PG&E Letter DCL-02-045

Docket No. 50-275, OL-DPR-80
Docket No. 50-323, OL-DPR-82
Diablo Canyon Units 1 and 2
Response to Final NRC Request for Additional Information Regarding Supplement 3
to License Amendment Request 00-06, "Alternate Repair Criteria for Axial PWSCC
at Dented Intersections in Steam Generator Tubing"

PG&E Response to NRC Request for Additional Information Received on March 11, 2002, Regarding Supplement 3 to LAR 00-06, "Alternate Repair Criteria for Axial PWSCC at Dented Intersections in Steam Generator Tubing"

Figure 1
Leak Rate as a Function of Crack Length
for Different Steam Line Break Differential Pressures

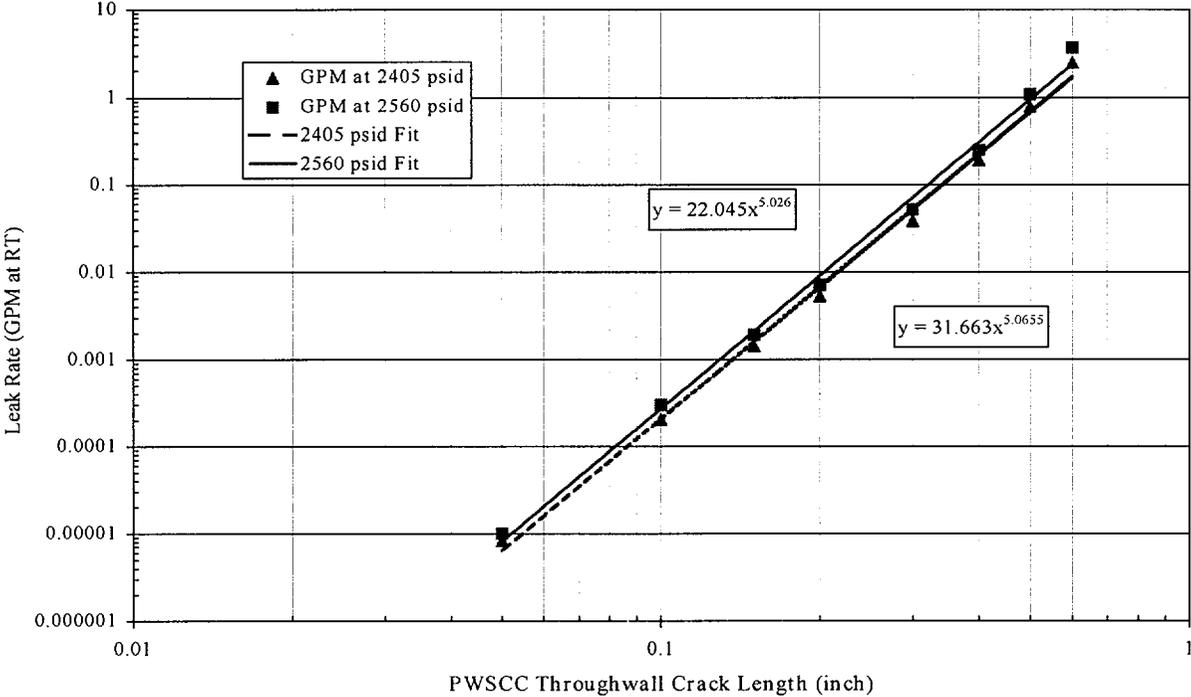
Additional Information, Applicable to SLB Differential Pressure of 2405 psi

The PWSCC ARC can be applied at Diablo Canyon Power Plant (DCPP) Units 1 and 2 for projected SLB differential pressures of either 2560 pounds per square inch (psi) when crediting the pressurizer safety valve setpoint or 2405 psi when crediting the pressurizer power-operated relief valve (PORV) setpoint. The 2405 psi pressurizer PORV setpoint value is based on the 2335 psig pressurizer PORV setpoint, plus 3 percent uncertainty. The 2335 psig pressurizer PORV setpoint is referenced in the DCPP Technical Specification Bases page B 3.4-45. The uncertainty value of 3 percent was adopted by the industry because it is consistent with Generic Letter (GL) 95-05 guidance. That is, GL 95-05 specifies a 3 percent adjustment for the pressurizer safety valve setpoint, and recommends a similar adjustment for the pressurizer PORV setpoint.

The information presented in Table 6-4 of WCAP-15573, Revision 1, was developed from test data and conditions near, but variant of the predicted SLB conditions. As such, the variance of the prediction errors should be such as to account for the difference between a SLB differential pressure of 2405 and 2560 psi. In other words, the parameters of the related equation 6-18 in WCAP-15573, Revision 1, are acceptable for both 2405 psi and 2560 psi. The SLB leak rate data in Table 6-5 of WCAP-15573, Revision 1, reflects CRACKFLO code leak rates at 2560 psi, and must be adjusted to reflect the difference in differential pressures. The data and regression parameters for differential pressures of 2405 and 2560 psi are provided in Table 1 and Figure 1 of this letter. In each, the information from WCAP-15573, Revision 1, is repeated for the 2560 psi differential pressure condition and new information is presented for the 2405 psi differential pressure condition. The equation parameters shown in Figure 1 are used as input to the PWSCC ARC code for the evaluation of the plant data. The relationship is of the form,

where Q is the leak rate in gallons per minute and L is the throughwall length of the PWSCC crack. The correction factors for the flow stress provided in Table 6-5 of WCAP-15573, Revision 1, are unchanged by the difference in SLB differential pressures.

Figure 2
Pulled Tube Destructive Examination Profile

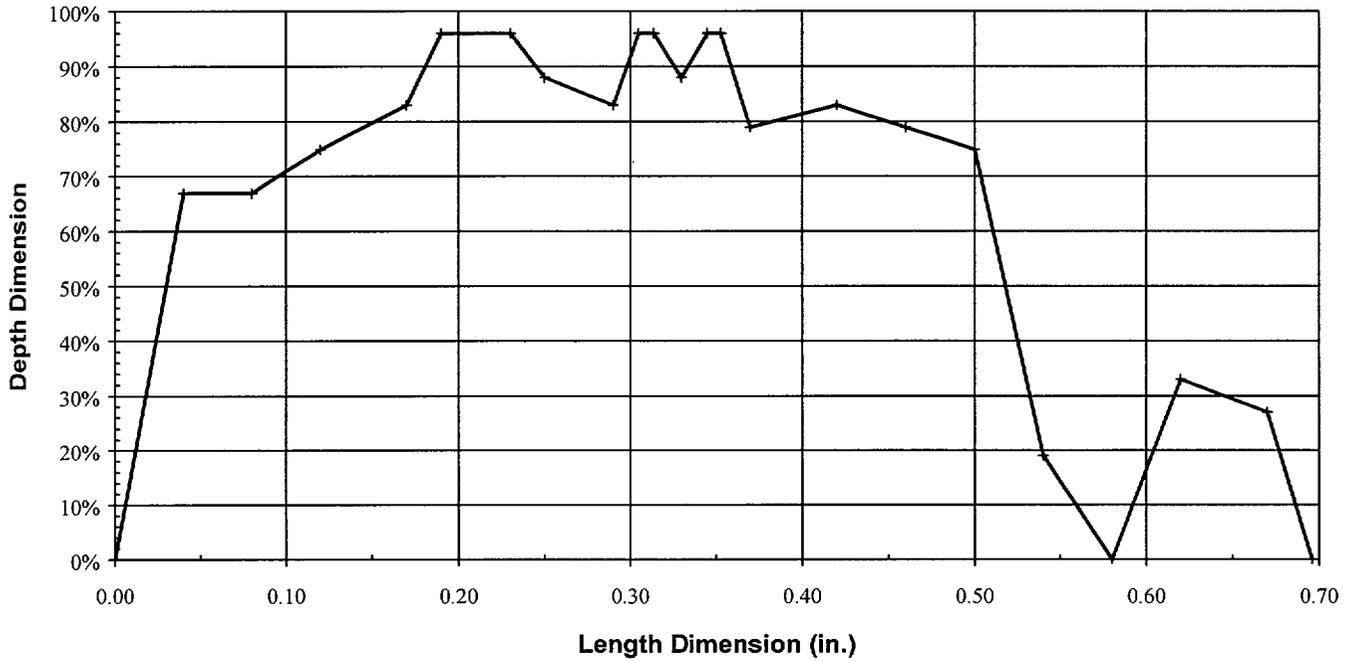
Supplemental Question

What additional evaluations can be performed to demonstrate that the throughwall crack lengths and leak rates are conservative for partial depth indications evaluated using the ligament tearing model with the weakest link method?

As noted above, the ODSCC indications were analyzed using the destructive examination profiles with and without inclusion of PWSCC NDE sizing uncertainties. The ODSCC Model Boiler (MB) specimen MB 607-3 is predicted to leak at much larger leak rates (1.87 gpm) than the measured leak rate of 0.02 gpm indicating conservatism in the tearing model. The leak rate for ODSCC specimen A-1 PT R28C35 is over-predicted by more than a factor of 50 when NDE uncertainties are included in the analysis. No leakage was predicted for ODCSS specimen A-1 PT R28C35 without NDE uncertainties in the analysis. The destructive examination profile for this indication is unusual with very short deep segments of 96 percent depth (0.04 inch, 0.009 inch, and 0.008 inch) separated by 83 percent to 88 percent deep segments that are 0.075 inch and 0.031 inch long as shown in Figure 2 in this letter. The remainder of the indication is less than or equal to 83 percent deep. Because the ligaments are relatively shallow (83 percent to 88 percent) and the deep segments are short, it is probable that models would not predict ligament tearing for this profile. For the indications that did not leak, only ODSCC specimen MB 543-4 is predicted to leak without inclusion of NDE uncertainties. The conservatism of adding NDE uncertainties, as typical of cases where the NDE profile is very close to or deeper than the destructive examination profile, leads to predicted leakage for six of the eight ODSCC indications that did not leak as well as the one PWSCC indication that did not leak.

Figure 7-1
Increase in Through Wall Crack Length from Ligament Tearing

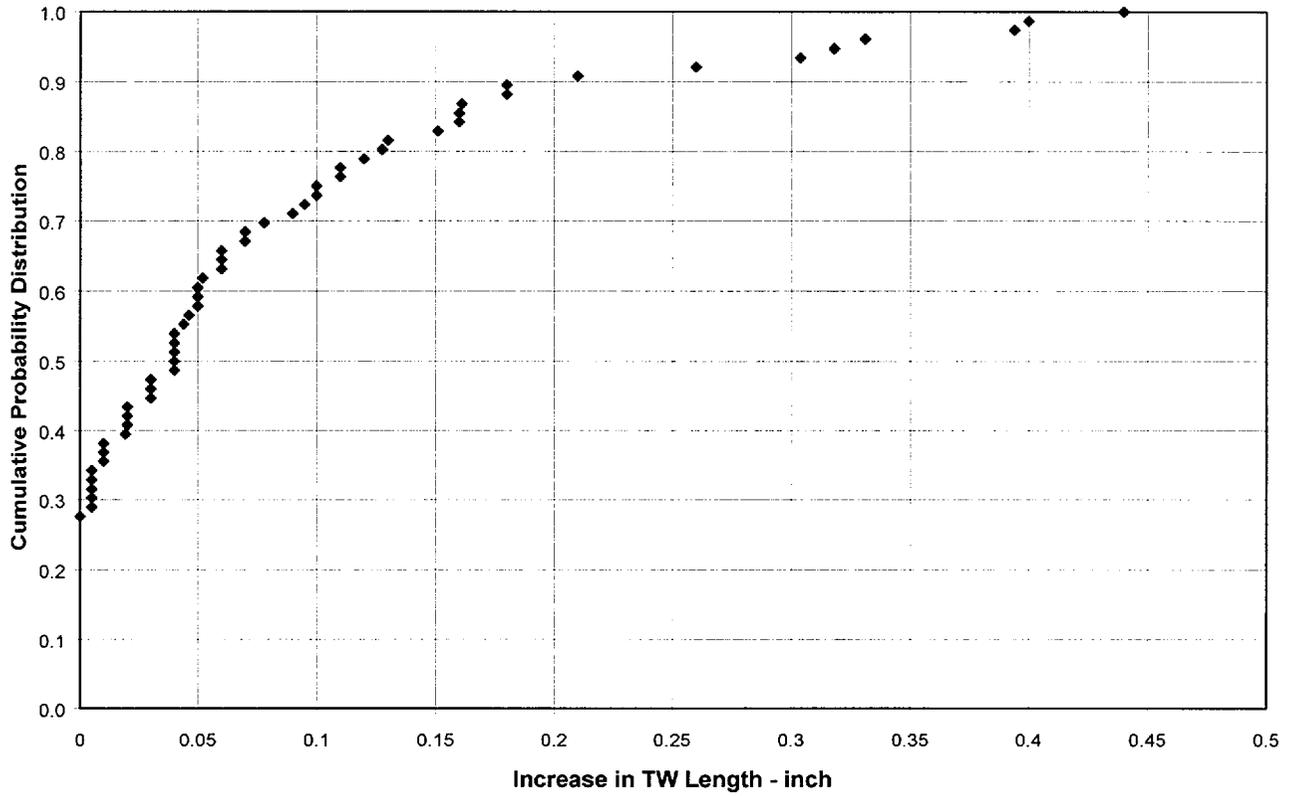
There is very little data confirming the conservatism of the entire leakage model. In particular, there is very little data verifying (1) that the ANL model conservatively predicts the length of the through-wall regions of a stress corrosion crack, and (2) the resultant leak rate calculated from CRACKFLO (based on these through-wall lengths) conservatively predicts the measured leakage from these flaws. In fact, there is only one PWSCC data point that can be used to validate the entire model. In this regard, discuss your plans to assess these various components of the leak rate model. For example (as discussed in the Sequoyah safety evaluation for this ARC), will crack profiles be determined by NDE prior to steam line break testing, will crack profiles be determined by post-test destructive examination, will the crack profiles then be input into the ANL model to determine predicted length of the pop-through region, will these results then be used to confirm the adequacy of the model?

The crack profiles obtained by post-test destructive examinations are the corrosion induced crack profiles as the causes of ligament tearing can be from the leak test, the burst test and/or the opening of the crack face to permit fractography for the crack profile. Consequently, the currently available data do not provide information on tearing lengths at SLB conditions.

Figure 4-14R2

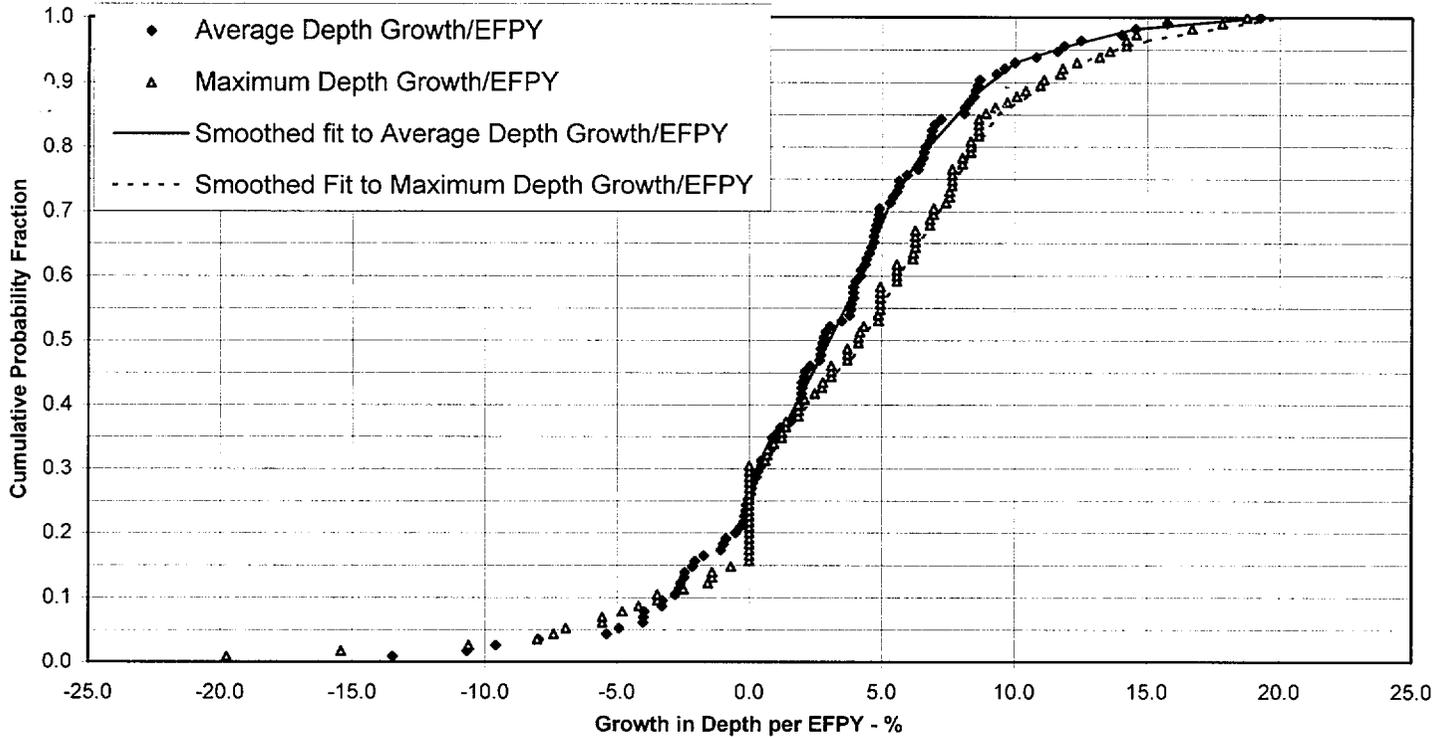
Errors in Diablo Canyon Power Plant Unit 1 refueling outage 9 (1R9) growth rate data for maximum depth, average depth, and length were found in Table 4.7R1 (and associated tables and figures) of PG&E Letter DCL-02-023, "Response to NRC Request for Additional Information Regarding Supplement 3 to License Amendment Request 00-06, "Alternate Repair Criteria for Axial PWSCC at Dented Intersections in Steam Generator Tubing," dated March 11, 2002. These errors have negligible effects on the growth rate distributions, and have no effect on the conclusions made in Letter DCL-02-023. This enclosure provides the following corrected tables and figures:
